SUBJECT: Executive Director's Report

<u>PUBLIC OPEN HOUSE: STATE ROUTE 49 MULTI-MODAL CORRIDOR</u> <u>IMPROVEMENTS (NEVADA CITY)</u>

Public Comment re: SR49 Multimodal Corridor Plan 11/12

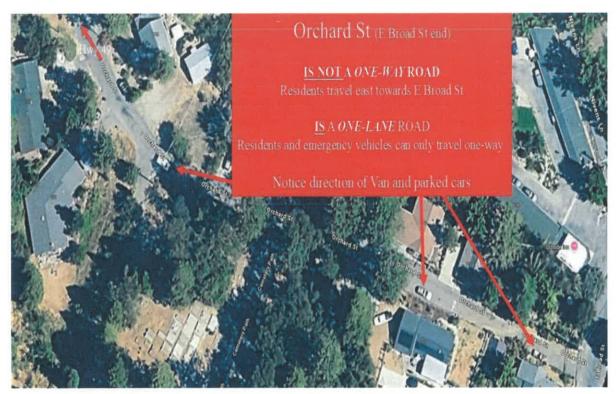
Orchard St is essentially a one-lane road. See attached pictures for detail. While there are One-Way signs at the Hwy 49 end, residents travel both ways: out to Hwy 49 and into Nevada City via Orchard and E Broad. Many residents do not have off-street parking and routinely park on the street, especially on the E Broad St end, leaving room for on-lane/one-way traffic only. Visitors also use the available on-street parking. Making it easier to use Orchard St to get to the Rood Center creates safety issues for Orchard residents, visitors, anyone travelling on Orchard and will likely impede emergency vehicles.
